2019-10-23

Subject: Addendum #1 - Environment Act Proposal, RM Gimli Wastewater Biosolids Storage Facility (June 13, 2018)

Client ref.: File no. 4522.10

Figure 6-1: Storage Facility Stages: Fill, Storage and Land Application Periods

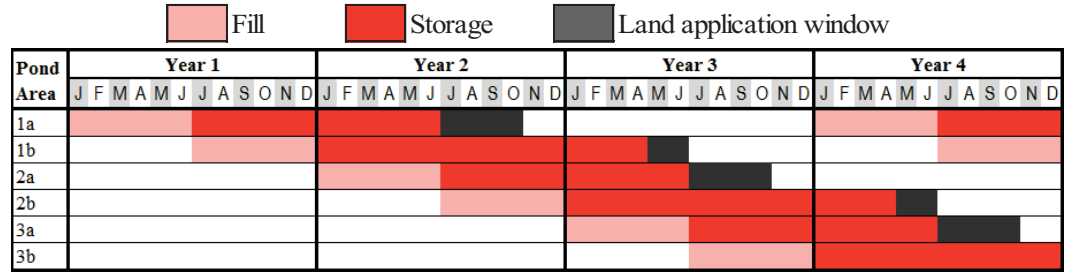
The biosolids facility is designed to provide 3 years’ worth of storage based on the future design biosolids generation. Within each individual pond are three storage areas (Pond 1a, 1b; Pond 2a, 2b; and Pond 3a, 3b). As such, each storage area (at design loading) will take 6 months to fill after which the biosolids will sit idle for a one-year period before being land applied. The cell will then remain unused for a year before resuming the process. This will allow the RM flexibility to delay the biosolids land application if conditions arise (e.g. wet weather) such that it is not feasible during the land application window.

Figure 6-1 details the fill and storage periods as well as the land applications windows for removal from the ponds.

1 PROPOSED SITE PLAN
NTS

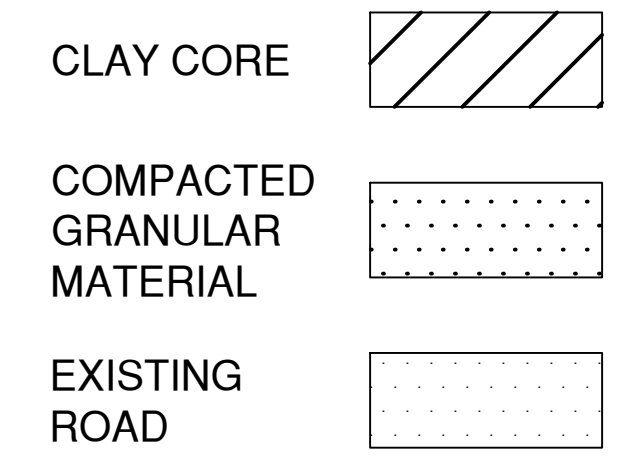
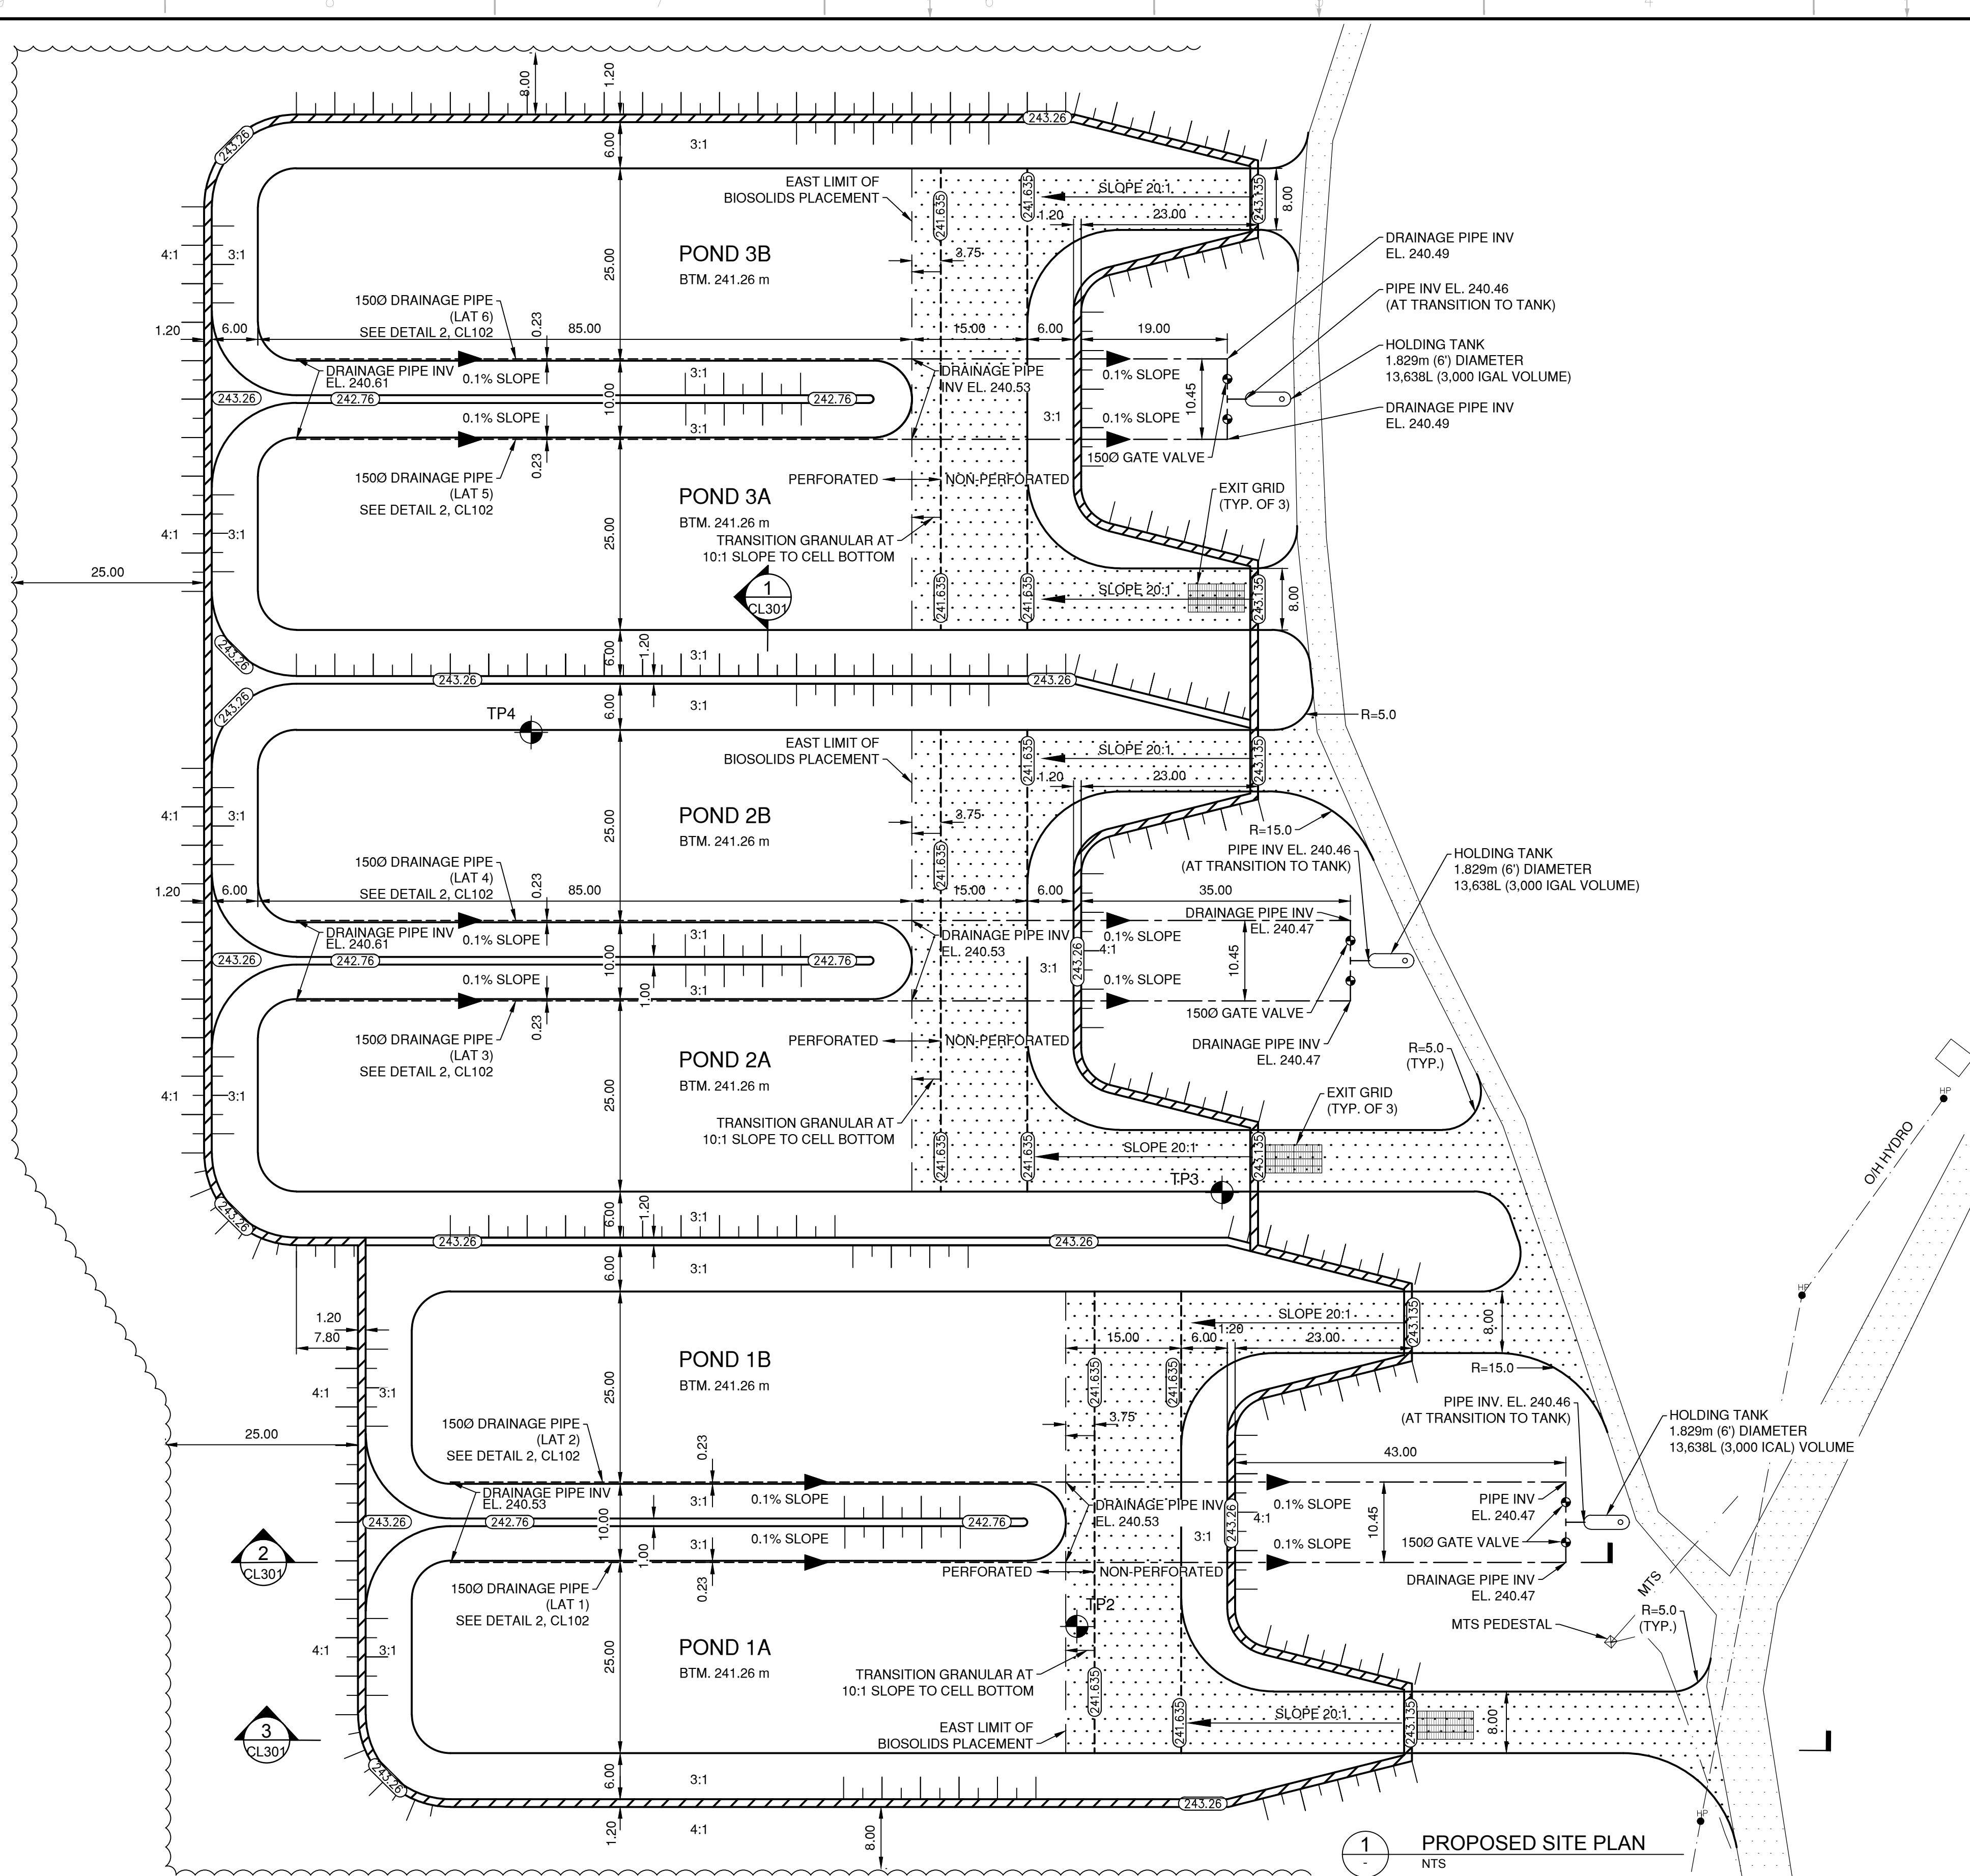
The new storage facility will be constructed as illustrated in the EAP design drawings (enclosed) and will be located in the southwest quarter of section 10-21-3 EPM.

Each of the six pond areas will have a capacity of 2,290 m³, thus the total biosolids capacity is 13,740 m³ for a three-year period. The anticipated future biosolids generation over three years is 12,812 m³.

The new facility will be constructed as detailed in the drawings. The interior side slopes of the constructed ponds will be 3:1 (horizontal:vertical) while the exterior slopes will be 4:1. The proposed ponds will have a 2.0 metre dyke height as measured from the interior finished pond bottom. The sludge is not to be stored in a pile higher than 1.0 m, allowing for a freeboard of 1.0 m. The dykes will be constructed with in-situ material in 150 mm lifts compacted to 95% Standard Proctor density with a 1.2 m thick clay core that is tied into the till material minimum depth of 0.3 m. The moisture content of the material should be minus two percent to plus 3 percent of optimum moisture as determined by the Standard Proctor test. Any unsuitable material such as coarse gravel and boulders should be removed. The top of the dykes will be 1.2 m wide.

A perimeter drainage ditch will be constructed around the new ponds, if required. Other ditching will be located as shown on the drawings. For disturbed areas where sediment or erosion control is deemed necessary, the contractor will be required to employ appropriate measures.

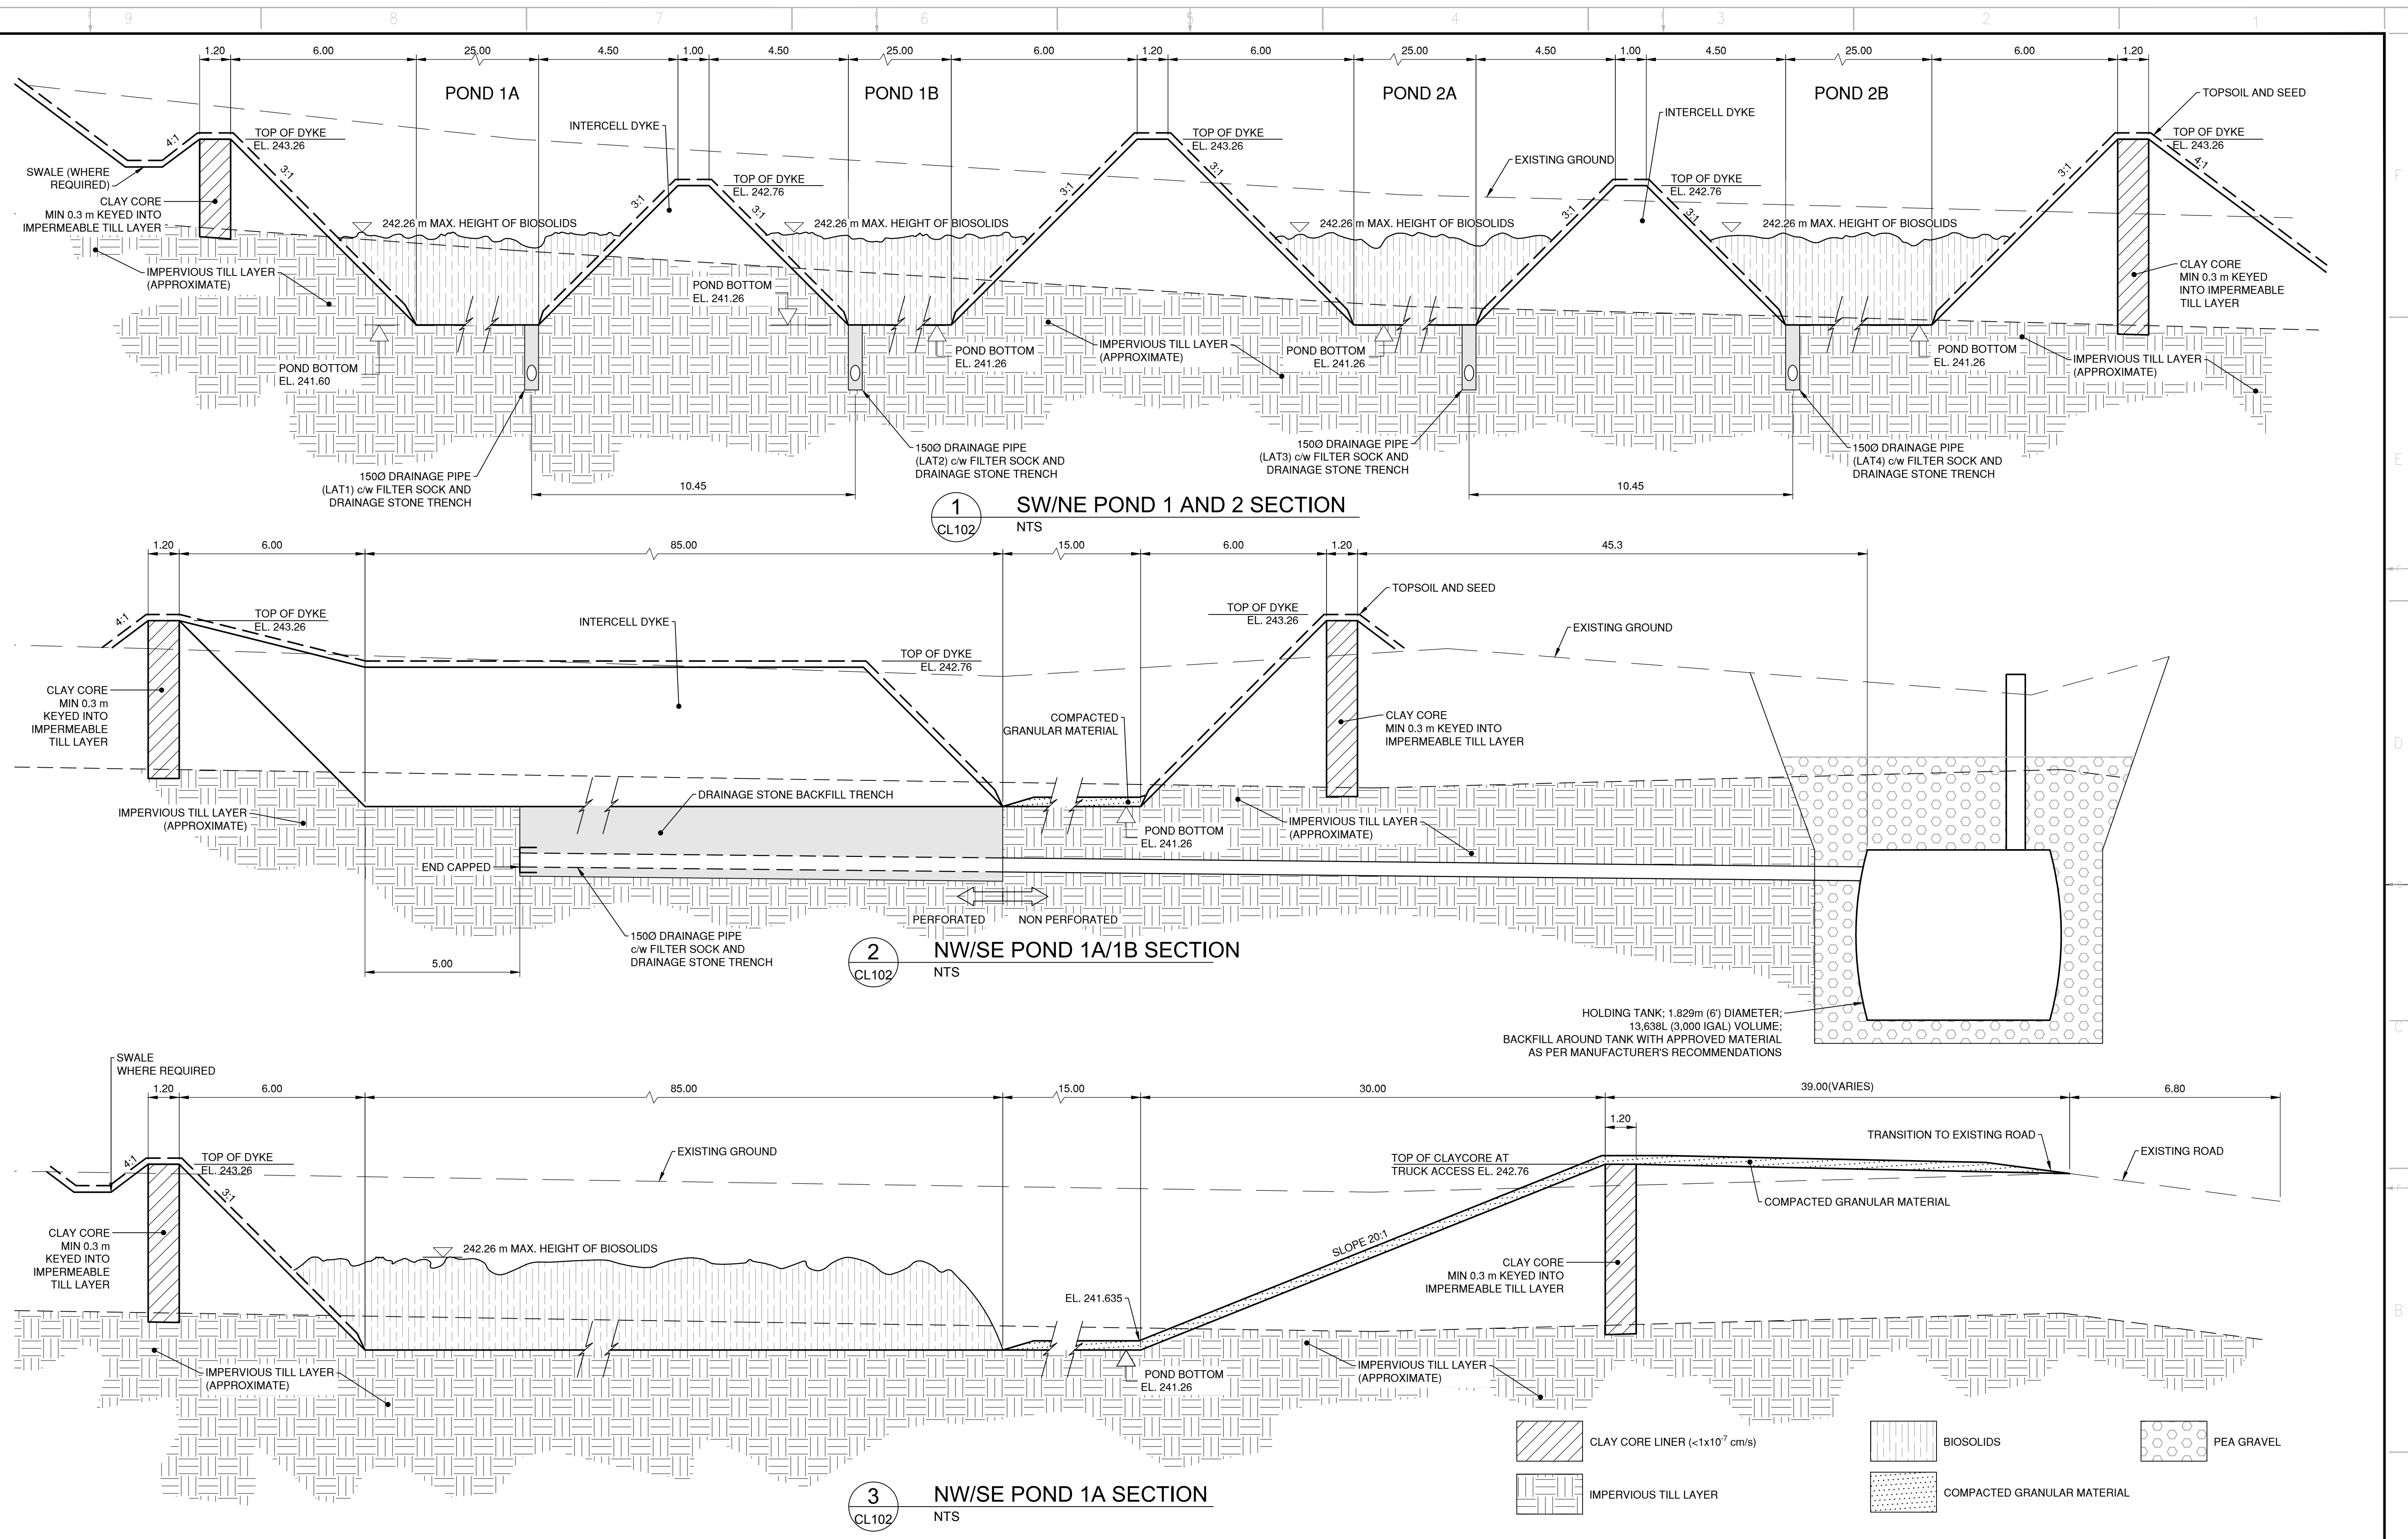
For pond construction, the proposed bottom of the proposed ponds will be the in-situ dense till and the dykes will be constructed with a 1.2 m thick clay core that ties into the till a minimum of 0.3 m, creating a continuous liner. The proposed development location has limited clay material present but in suitable quantities to be used for the clay core in the perimeter dykes. Testing of the clay core will be based on collecting Shelby tube samples and determining its hydraulic conductivity using the falling head permeability test method. Based on preliminary discussions with Manitoba Sustainable Development we anticipate that if liner testing on the pond bottom floor is required, it proposed that it be completed by obtaining block samples and the hydraulic conductivity be determined using a one-dimensional consolidation test.
